APPLICATION NO.	FILING DATE	FIRST NAMED INVENTOR	ATTORNEY DOCKET NO.	CONFIRMATION NO.
10/816,371	04/01/2004	Christoph Becke	2001P14042WOUS	9654
46726 7590 08/20/2007 BSH HOME APPLIANCES CORPORATION INTELLECTUAL PROPERTY DEPARTMENT 100 BOSCH BOULEVARD NEW BERN, NC 28562			EXAMINER WILKENS, JANET MARIE	
			ART UNIT 3637	PAPER NUMBER
			MAIL DATE 08/20/2007	DELIVERY MODE PAPER

Office Action Summary	Application No. 10/816,371	Applicant(s) BECKE ET AL.	
	Examiner Janet M. Wilkens	Art Unit 3637

Attachment A

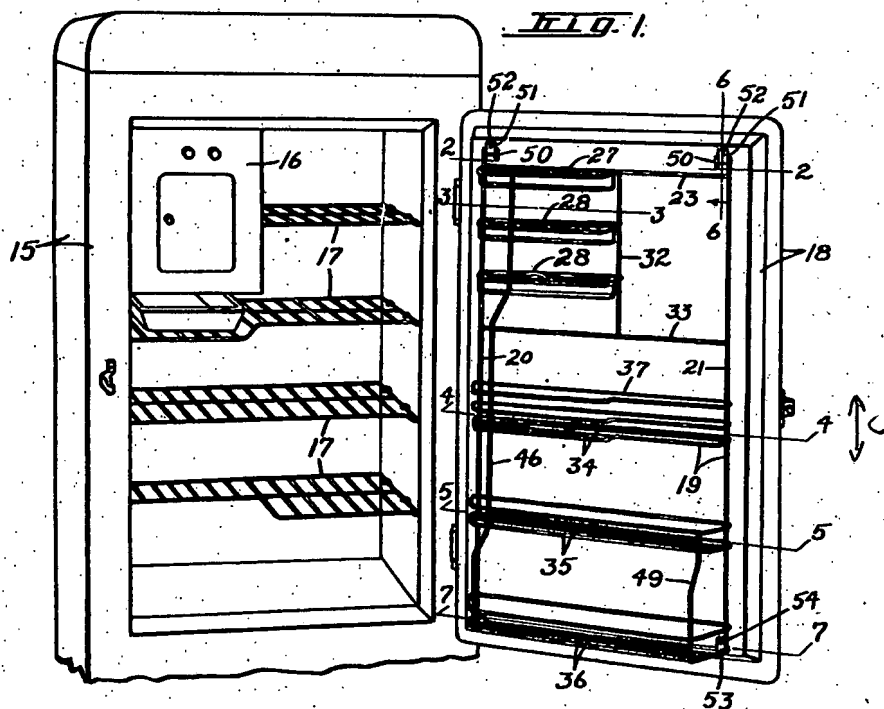
Claims 9, 10, 12, and 13 are rejected under 35 U.S.C. 102(b) as being anticipated by Gentz (2,074,785). Gentz teaches a refrigerator having a door with door storage compartment (Fig. 1; see Attachment A) comprising: at least one first generally boxed storage compartment portion (a) having a full first horizontally-directed depth (b) and a first vertically-directed storage depth (c); and at least one second generally boxed shaped storage compartment portion (d) having a front wall (front bars), the second storage compartment portion having a second horizontally- directed depth (e) being less than the full first horizontally-directed depth and following the first storage compartment portion in a longitudinal direction of the door storage compartment, and the front wall of the second storage compartment portion having a second vertically-directed storage depth substantially the same as the first vertically-directed storage depth (c), whereby the second vertically-directed storage depth of the second storage compartment portion is substantially the same as the first vertically directed storage depth. The compartment portions are separated by an intermediate wall (39).

Claims 11 and 16 are rejected under 35 U.S.C. 103(a) as being unpatentable over Gentz. As stated above, Gentz teaches the limitations of claim 9, including two portions of a compartment with substantially equal lengths, the portions having different depths. For claim 11, Gentz fails to teach that the portions have different lengths. However, it would have been an obvious design consideration to one having ordinary skill in the art to dimension the portions as desired, including forming them with different lengths, depending on the desired need of the person designing/constructing the compartment (and/or refrigerator), e.g. depending on intended storage uses, for aesthetic reasons, etc.

For claim 16, Gentz fails to teach that the second depth is less than half the first depth. However, it would have been an obvious design consideration to one having ordinary skill in the art to dimension the second section as desired, including forming its compartment with a smaller depth, depending on the desired need of the person designing/constructing the section (and/or refrigerator), e.g. depending on intended storage uses, for aesthetic reasons, etc.
